JOB NAME
Warner Est.
SUNLIGHT HOUSE
85 Quay Street
Manchester M60 3JA

STATUS
planning

DRAWING TITLE
PROPOSED ELEVATIONS

JOB NO. 3419 PL DRAWING NUMBER 5001 REV A

PROPOSED MAIN ENTRANCE ELEVATION

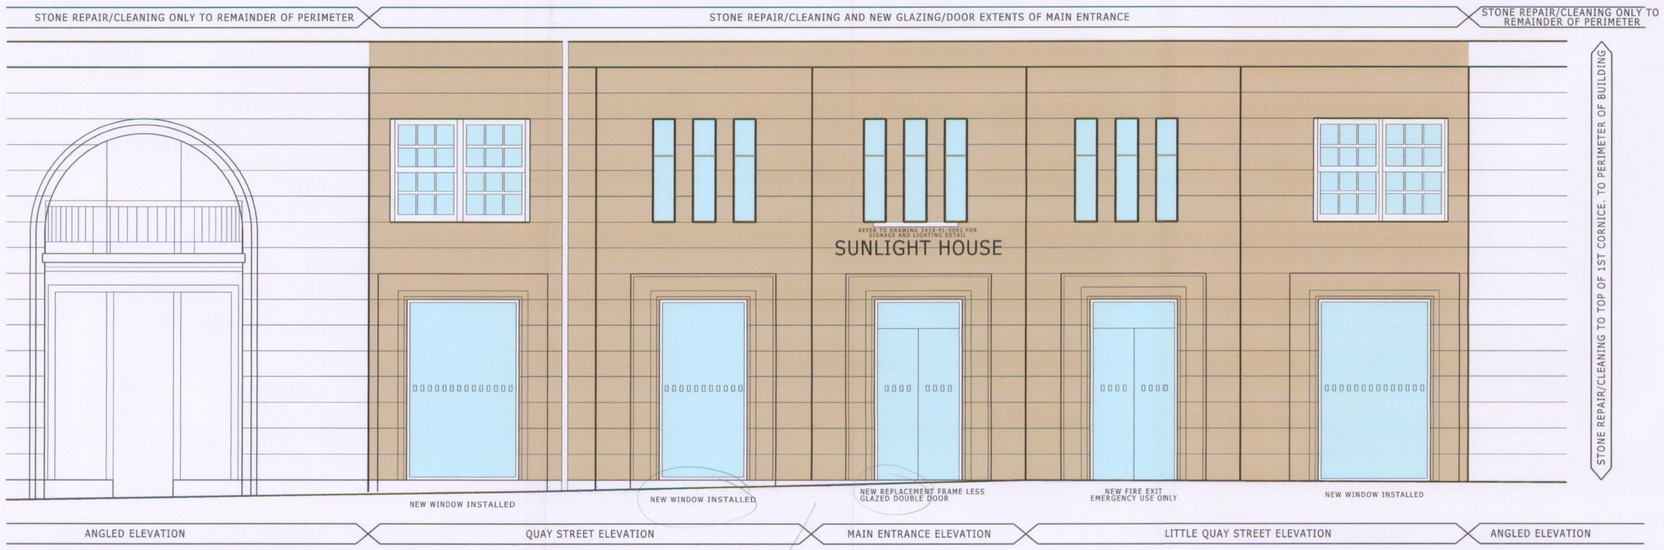
A. Omitted timber framing from Main Reception Windows. New glazing to have minimal frame. All as per Conservation & Planning departments recommendations. ALS 20/03/08
REV. DESCRIPTION INITIALS/DATE
